## PRODUCT/PROCESS CHANGE NOTICE (PCN)

PCN #: **TB0605-05** DATE: **7/01/06**

Product Affected: **CVBGA 52L & 56L Products**  
**shipped in tray**

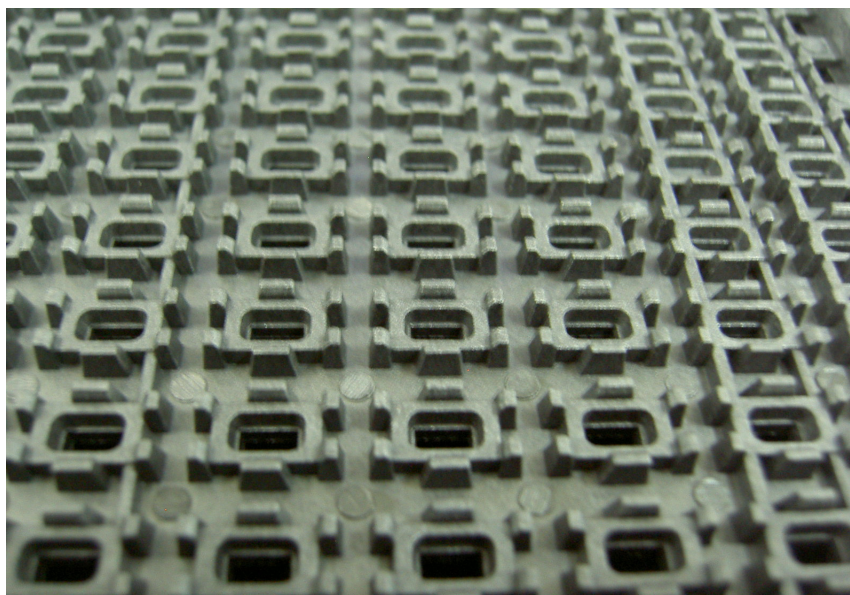
**Detail of Change:** This notification is to advise our customer that IDT has qualified new shipping trays for CVBGA 52L and 56L products. The new trays provide better protection during product shipment.

Please note that there will be a change in number of units per tray from 325 to 364 units/tray. There is no change in the tray dimensions.

Description	Existing Shipping Tray	New Shipping Tray
Part Number	12C-4570-E19	1QG-4570-F19
Tray Matrix	13x25	14x26
Qty per Tray	325 units	364 units
Pocket Size (WxL)	4.67x7.17 +/- 0.08mm	4.64x7.14 +/- 0.08mm
